# Wisconsin Department of Transportation

### NOTICE TO ALL CONTRACTORS:

**Proposal #07: 1060-28-70, WISC 2017317**  
**Marquette Interchange**  
**Bridges – IH 43/IH 94/IH 794**  
**IH 43/IH 94/IH 794**  
**Milwaukee County**

This is Addendum No. 01, which provides for the following:

POLYESTER POLYMER CONCRETE OVERLAY  
SHEET 1 OF 2  
319A

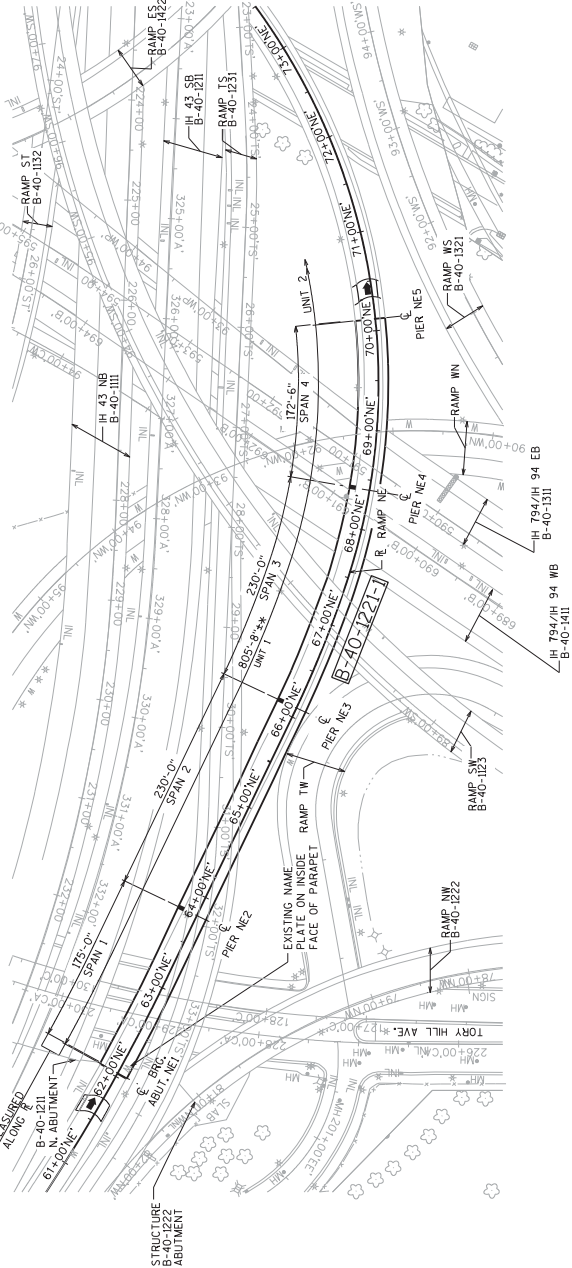
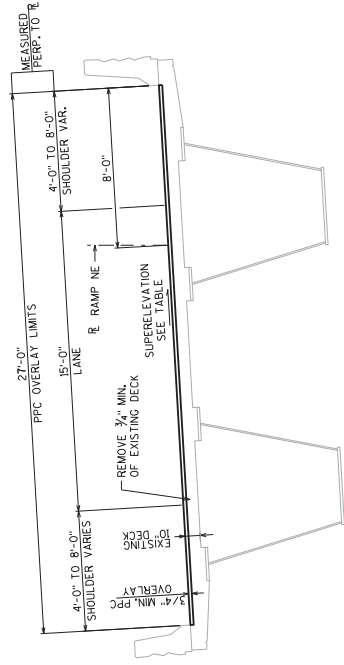
Added Plan Sheets	
Plan Sheet	Plan Sheet Title (brief description of why sheet was added)
319A – 319B	Structure B-40-1221-01 (plan sheets for this structure were omitted from the plan)

Addendum No. 01  
ID 1060-28-70  
Added Sheet 319A  
May 19, 2017

NO.	DATE	REVISION	BY
STATE OF WISCONSIN DEPARTMENT OF TRANSPORTATION STRUCTURES DESIGN SECTION			
STRUCTURE B-40-1221-01			
DRAWN BY		PLANS ADS	
CHECKED BY		M.J.H.L.C.D.	
FIELD SPLICE PAINTING DETAILS			SHEET 2
			319B

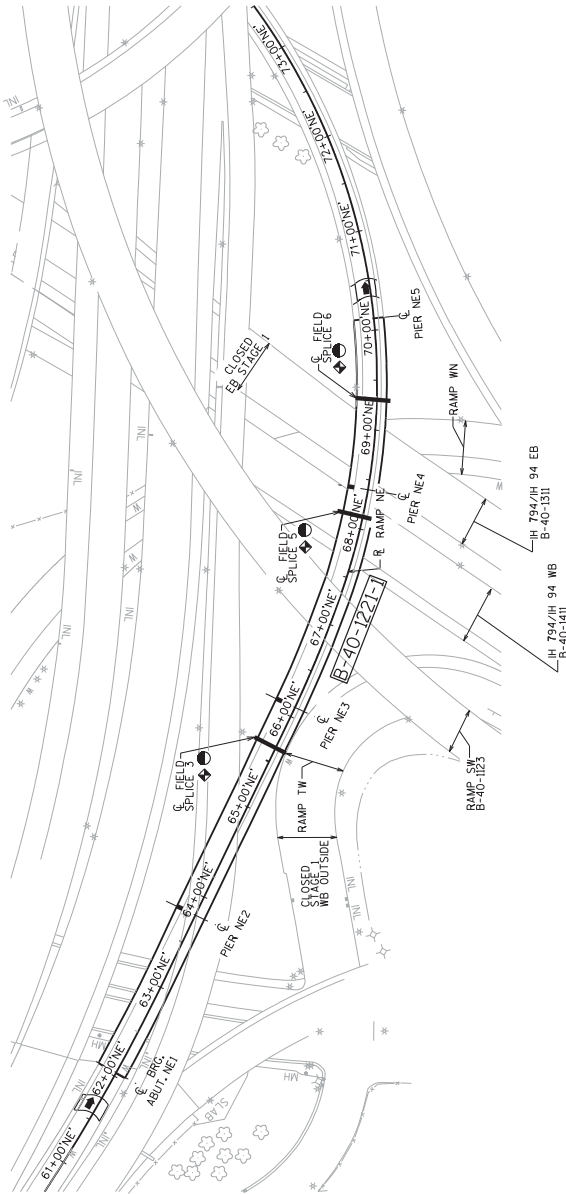
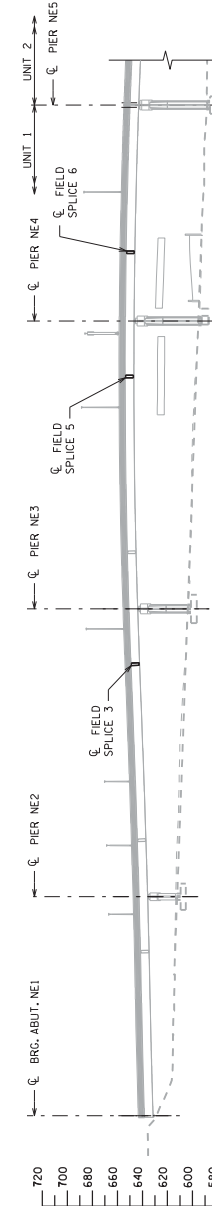
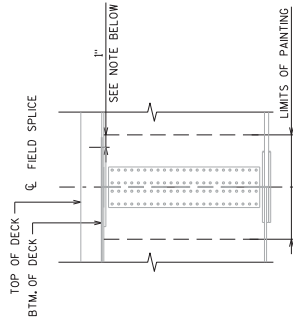
Addendum No. 01  
ID 1060-28-70  
Added Sheet 319B  
May 19, 2017
